SSDA RESPONSE TO SUBMISSIONS REPORT

MELROSE PARK SOUTH – EAST – BLOCK 05

REPORT PREPARED BY FK ON BEHALF OF WHARF AND HUGHES DEVELOPMENTS PTY LTD

JAN 2026

B5 COS ENTRIES DA-E-B5-AR-255 SERIES

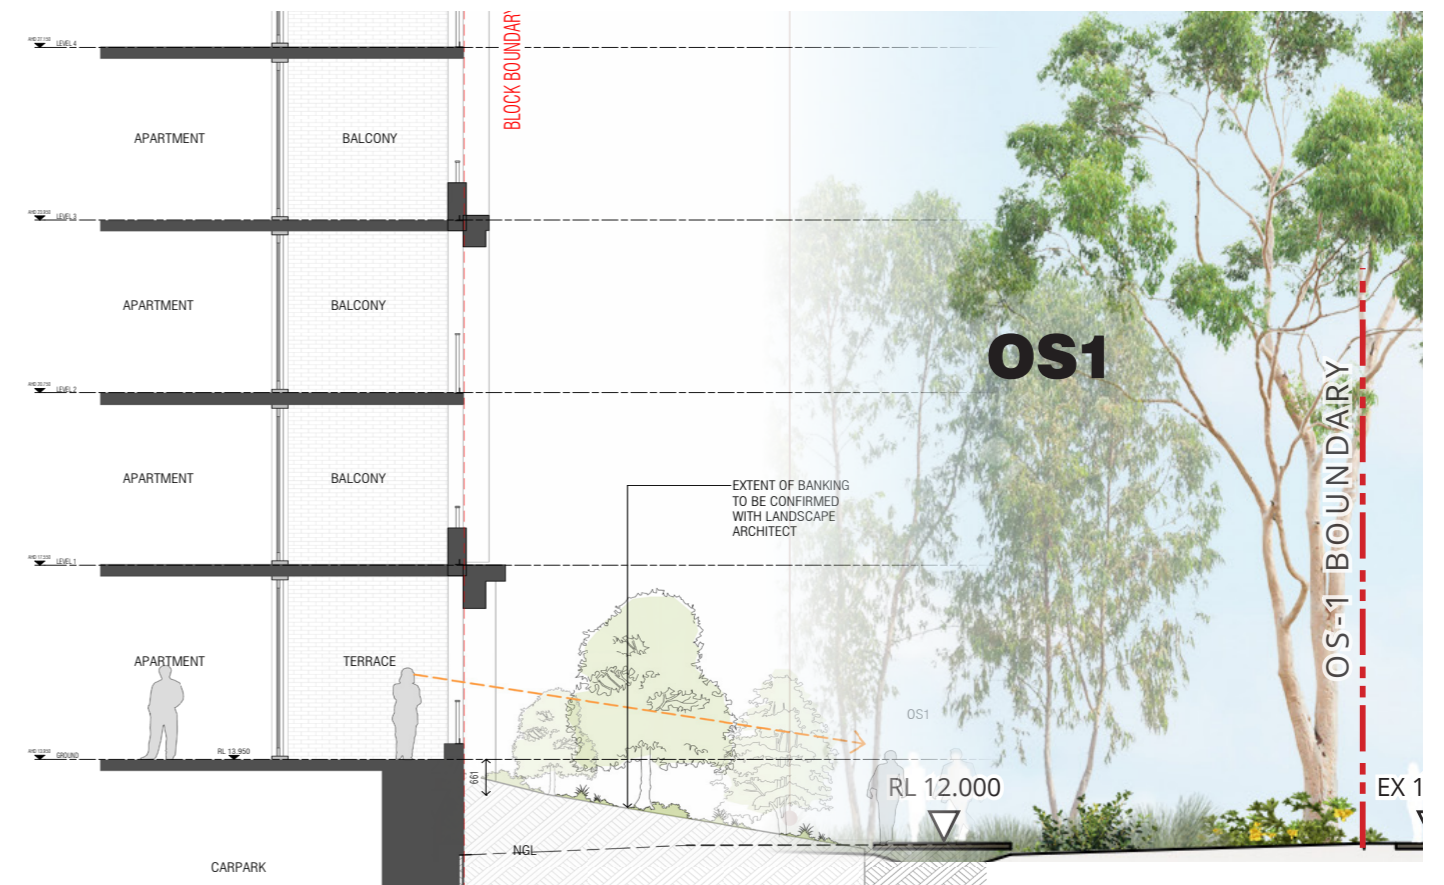
- The proposal fails to achieve design excellence creating a poor streetscape to Wharf Road.
- Basements are located 1m to 3m above the streets and park frontages creating a poor streetscape. To ensure that the basements are integrated into the landscape they are to be located so that the top of the basements are level with most of the streets surrounding the block.[...]
- Communal courtyards are located on the top of the basements so that views from the streets to the courtyards (EW Rd 9, NS Rd 6 and the Wharf Road Gardens) are limited by the stairs and solid walls.

- The updated design integrates landscape terrain mounding up to the building edge, softening the interface with Wharf Road while maintaining privacy for residents. This approach enhances the pedestrian experience and contributes to a cohesive and visually appealing streetscape, as well as mitigating portions of the basement projection.
- The courtyards are intentionally elevated so that views from both the buildings and courtyards are lifted above street level, improving privacy for residents while maintaining the intent of the ADG section 4L-2 Ground floor apartments. Landscape and level changes are sensitively designed to maintain filtered visual connections to surrounding streets and open spaces while providing residents with usable communal areas

- The courtyards have been designed as multifunctional open spaces that balance circulation requirements with areas for recreation, passive enjoyment, and planting. Level changes are minimised where possible and integrated into the landscape to ensure the courtyards remain functional, attractive, and well-connected.

Planters are reduced in height towards street fronts, landscaping falls to the street to reduce visible planter walls and enable visual connections between public and private areas.

DA-E-B5-AR-098 BASEMENT O1 FLOOR PLAN

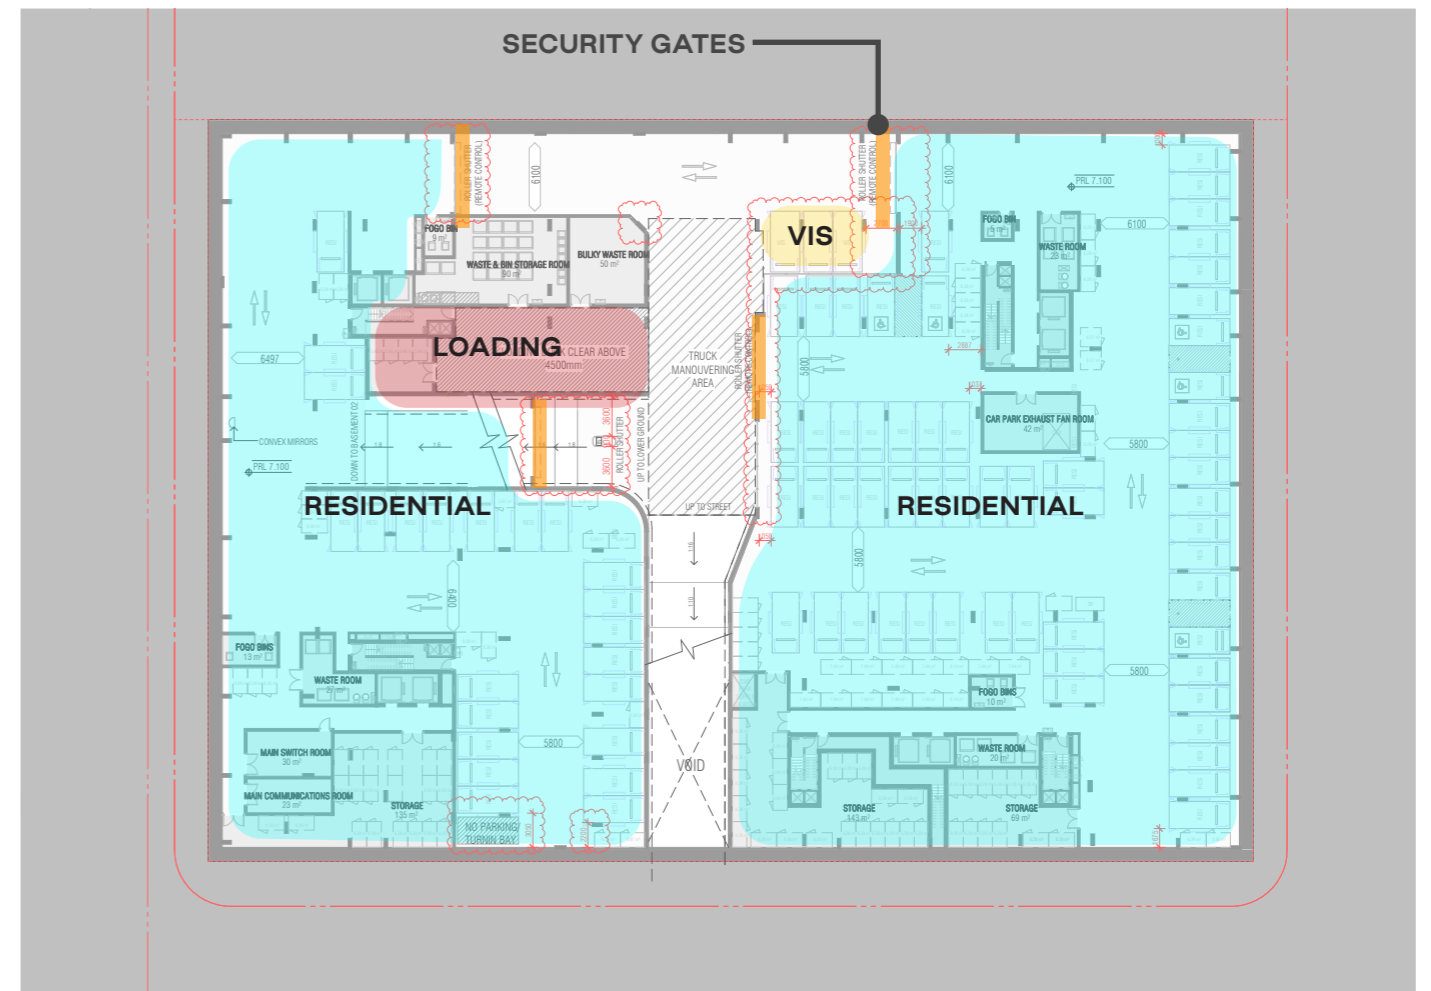
- Bicycle parking and motorcycle parking is to be provided as specified in the TIA and must comply with the relevant Australian Standards.
- With regards to the design of the carpark, the following issues have been identified:

- [...] 1m blind aisle extensions have consistently not been provided in accordance with Australian Standard requirements. Plans are to be updated to provide these to ensure satisfactory manoeuvring into the parking spaces.

- There are a number of locations throughout the car park where columns appear to be conflicting with the vehicle envelope in accordance with the Australian Standards. Plans are to be updated and the vehicle envelope should be illustrated on revised plans.

- The location of the driveway may be contradicting with a street tree. Accordingly, the design plans for the Infrastructure DA are to be amended to take into account the driveway location. It is recommended that a condition be included in this SSD for those plans to be updated to ensure this is not missed.

- The location of the control point into the basement car park is not shown. The control point must comply with the requirements of the Australian Standards and must ensure that no vehicles are obstructing the road reserve including the footpath. Swept paths for loading vehicles will also need to be checked to ensure service vehicles will be able to travel around any intercom/card reader if being used. An updated TIS should be required to perform this assessment.
- Devices, such as convex mirrors, will need to be installed at locations where vehicles will not have clear view of oncoming traffic and the aisle width is narrow preventing continuous two-way movements. The TIA is to perform this assessment and nominate the devices and locations they are to be installed.

- The car park layout has been reviewed and the plans have updated to include compliant blind aisle extensions to ensure satisfactory maneuvering into all parking spaces.
- A detailed check of all structural column locations relative to vehicle envelopes has been

undertaken. Vehicle envelopes have been illustrated on the revised plans to demonstrate full compliance with Australian Standard requirements.

- The Infrastructure DA design plans will be amended to remove street tree contradicting with driveway location. Please refer to DA-E-B5-AR-099
- The location of the vehicle control point are shown on the updated plans. The design will ensure compliance with Australian Standards, including confirmation that queued vehicles will not obstruct the road reserve or footpath. Swept paths for loading and service vehicles around the control point/intercom/card reader will be provided as part of the updated traffic report.
- The Traffic engineer have reviewed all internal car park locations. Where sight lines may be restricted convex mirrors or equivalent traffic control treatments have been nominated in their report. These will be adopted by the architectural drawings in DD

DA-E-B5-AR-099_LOWER GROUND PLAN - SE LOBBY

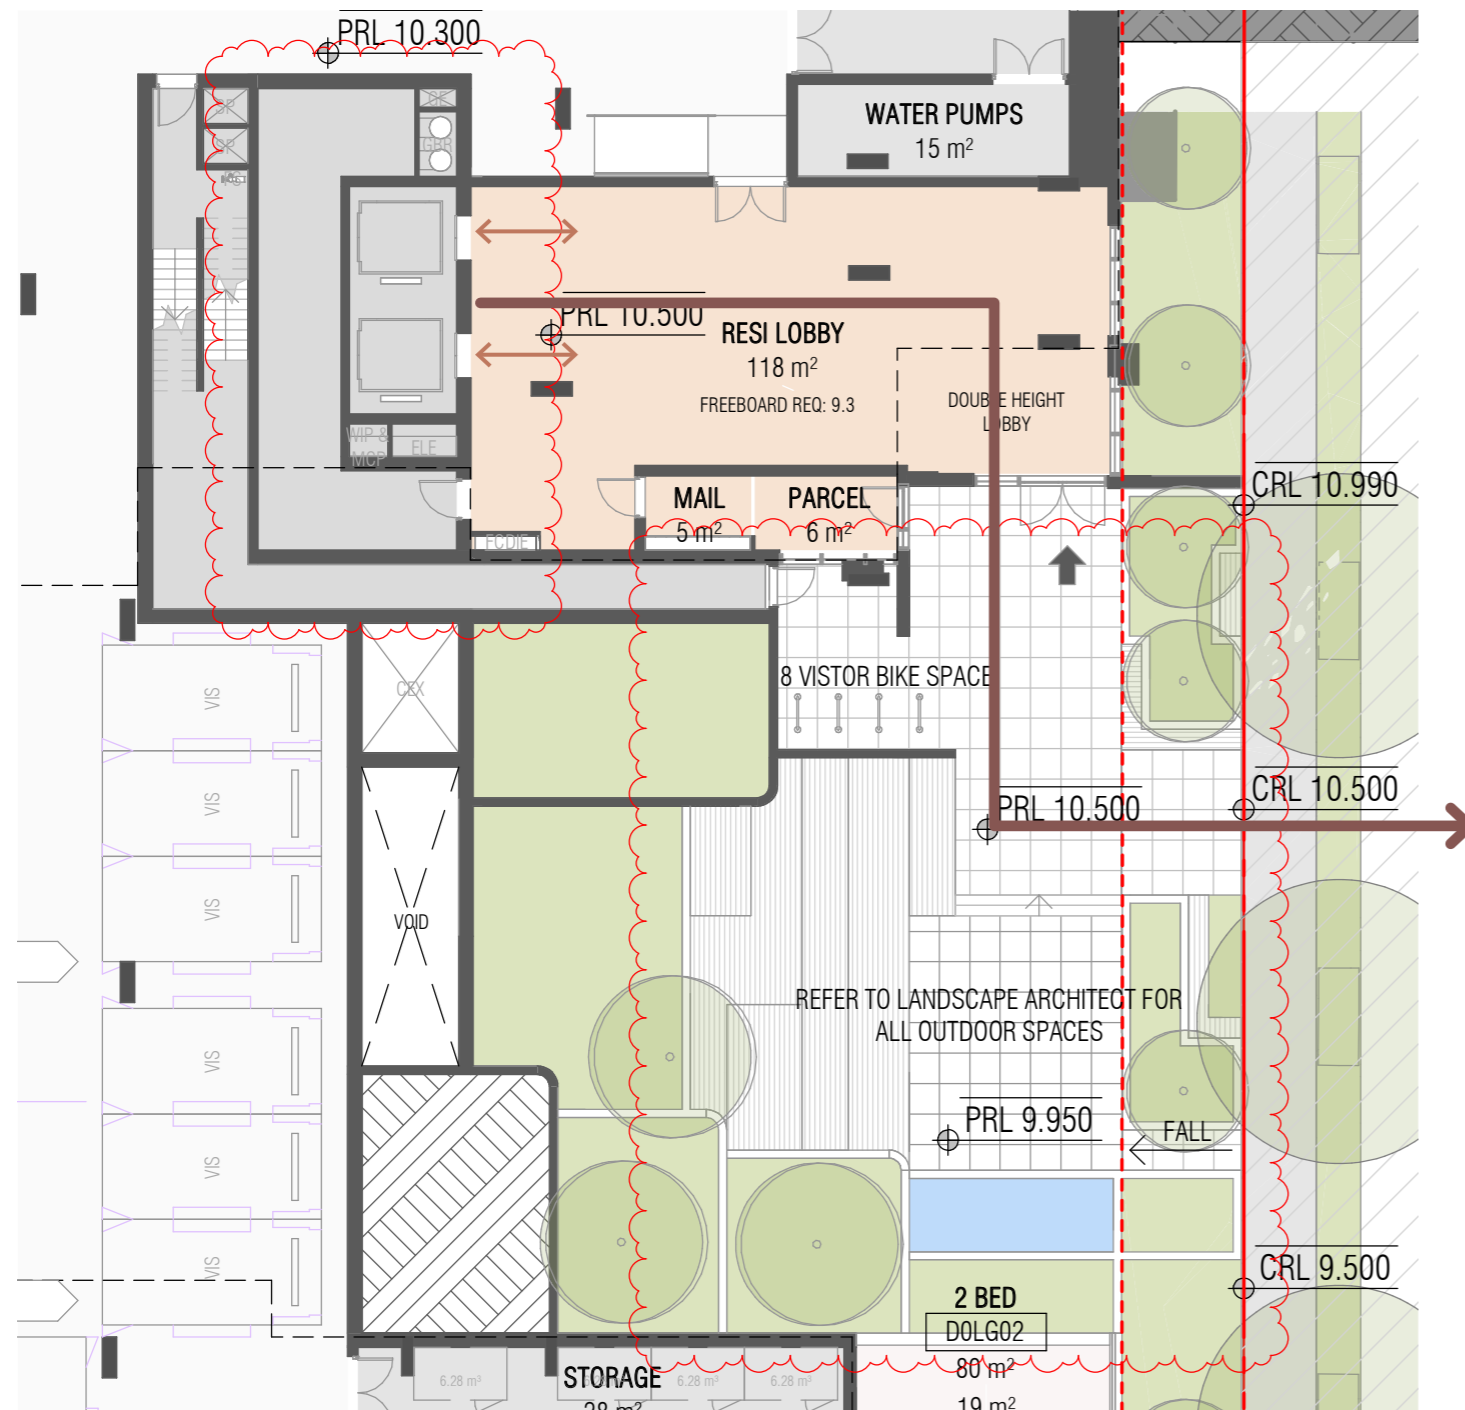
- The SE entry lobby and its adjacent entry court are located more than a metre below street level – which is counter to the prevailing slope. The SE entry is further compromised by the location of the lifts, which require walking around the core via a narrow corridor, which is also below ground with no natural light.

- The courtyard space adjacent to this entry requires further refinement and simplification to improve its relationship to the street level and avoid a sunken unsafe space.

- The SE entry court to lobby has been relocated further north to align with the prevailing street level, resulting in a level and more legible entrance condition. This adjustment removes the previously sunken entry and significantly improves accessibility, safety, and passive surveillance from the public realm.

- To address concerns regarding lift access in the SE lobby, a direct-through lift arrangement has been introduced. This eliminates the need to walk behind the lift core via a narrow, below-ground corridor and improves wayfinding, convenience, and amenity. The revised lift access is now naturally integrated within the entry sequence.

Lobby RL lifted to 10.6 To align with street interface

The SE lobby has been relocated north to align with street level, creating a clear and accessible entry.

DA-E-B5-AR-100_GROUND FLOOR PLAN - LOUNGE AREA

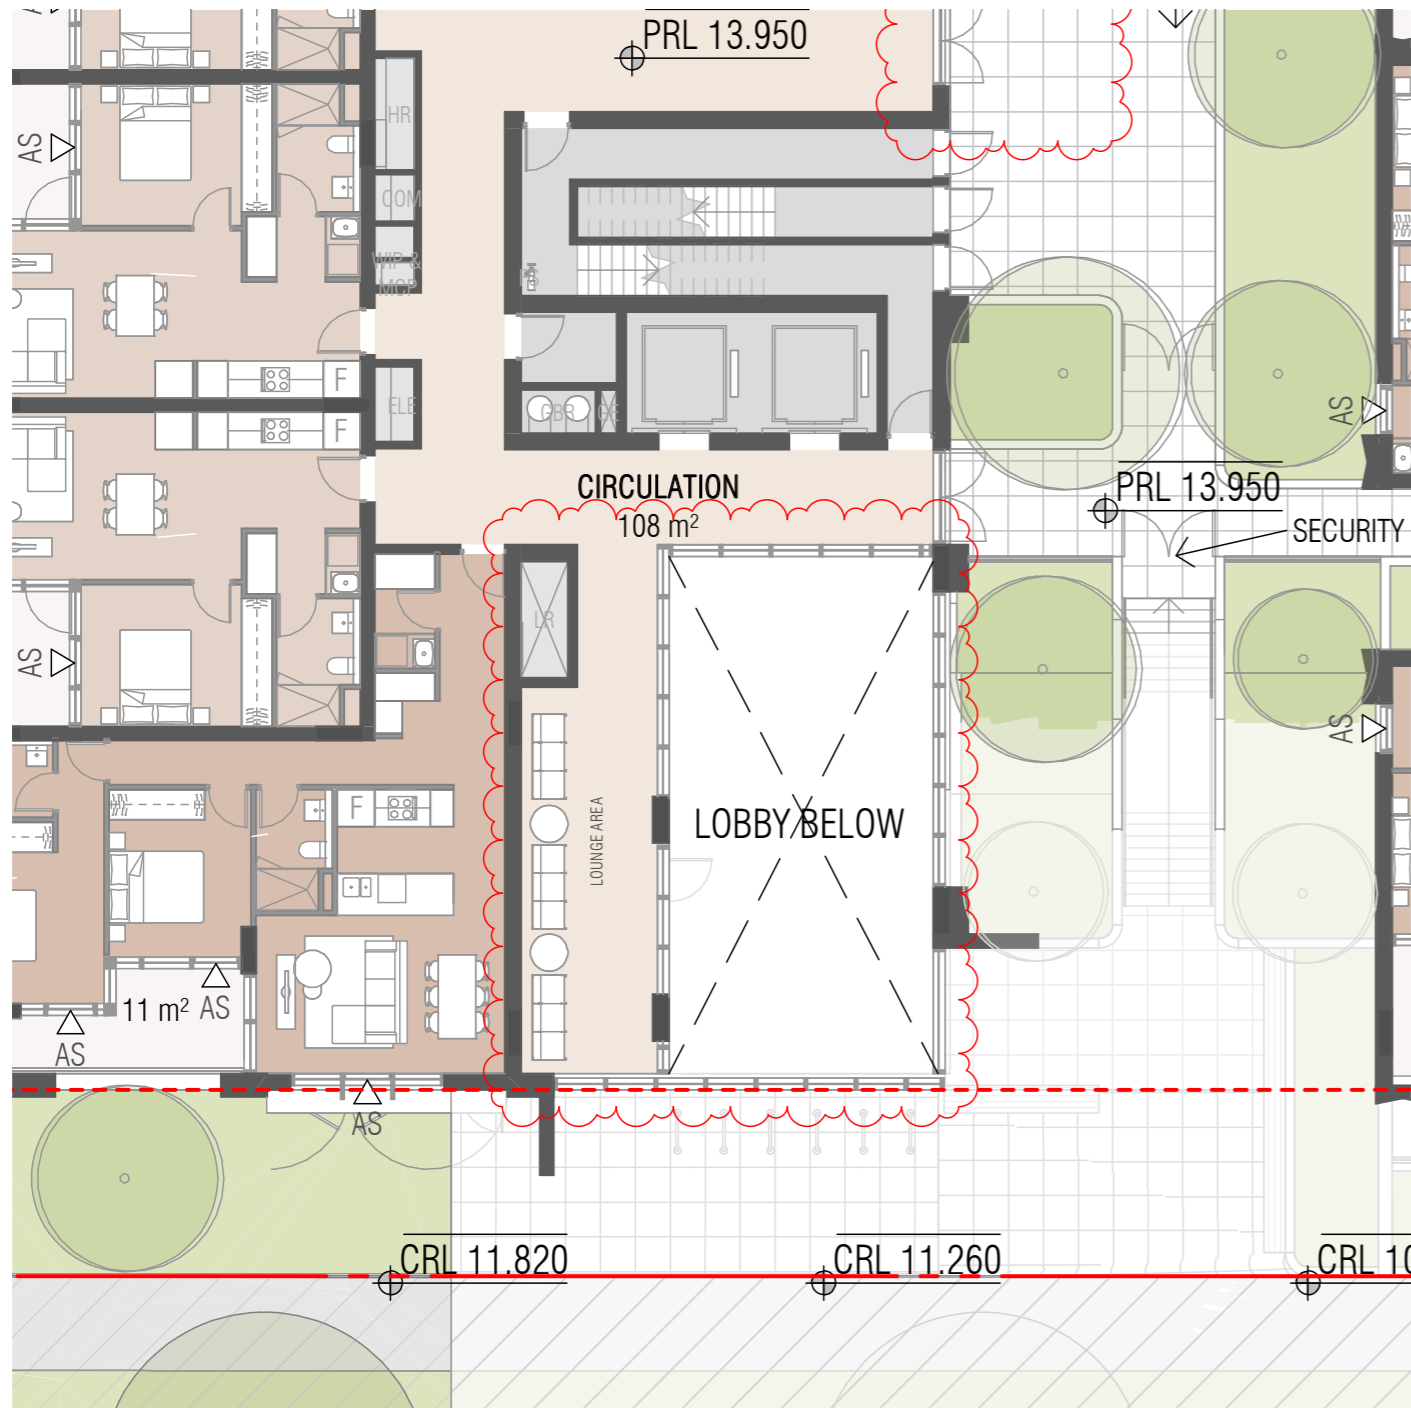
- The SW and NE lobbies still need further refinement, in particularly column placement and access to entry doors.
- The NW lobby includes a double height void that is unresolved, as it currently straddles the ground level mail, parcel and plant rooms. Further review of this entry is required to resolve the form and character of this double height void.

- There does not appear to be a gate to the open steps leading to the courtyard adjacent to the NW lobby, which may raise CPTED issues.

- In the NW lobby, a lounge area has been introduced above the mail room, parcel room, and fire control room on the ground floor. This provides a

more resolved architectural outcome, enhances resident amenity, and establishes a clear form and character for the NW entry without compromising functional spaces at ground level.

- A gate to the open steps leading to the courtyard adjacent to the NW lobby has always been provided as part of the design. This element remains unchanged and ensures controlled access and appropriate CPTED outcomes.

DA-E-B5-AR-150_ROOF PLAN

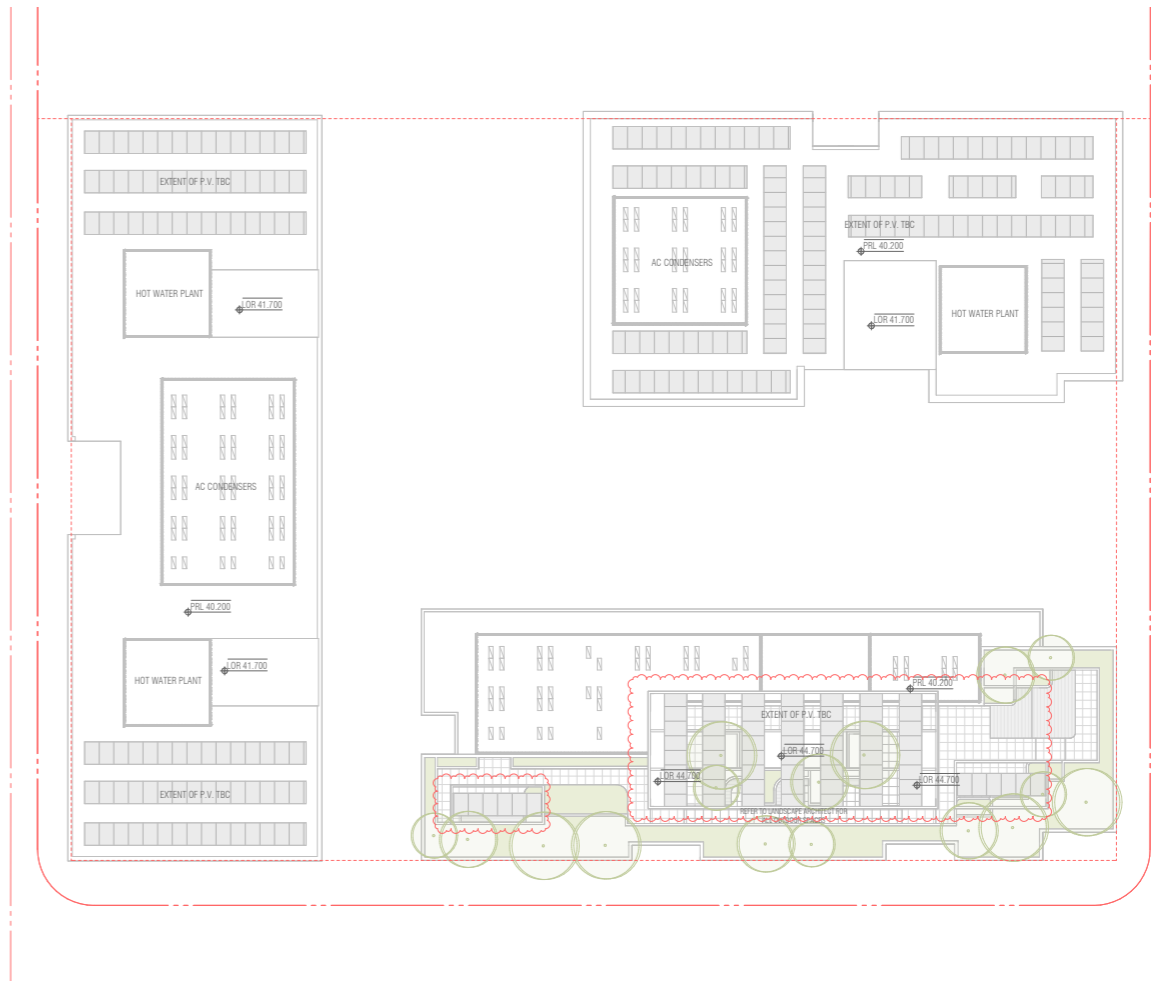
- The roof feature is excessively large and does not specifically respond to the amenity requirements of the rooftop open space. It should be reduced in scale to a simple roof form spanning the service cores only, which will reduce its visual and physical bulk. The covered areashould relate to the function of the spaces it protects and needs to demonstrate a relationship with the adjoining buildings. The Panel suggests decreasing its current size to increase the amenity of the space.

- The roof feature has been revised and its footprint significantly reduced, as shown on the updated drawings. The amended design adopts a simpler roof form spanning the service cores only, substantially reducing both its visual and physical bulk.
- Smaller, lower-scale pergolas are proposed to provide shade to select seating areas only, ensuring coverage is directly related to the use and function of the rooftop spaces.
- The overall reduction in built form increases access to open sky and views, enhances the usability and amenity of the rooftop open space, and improves the building's relationship with adjoining developments. The revised scale and form result in a more contextually appropriate and visually restrained rooftop outcome.
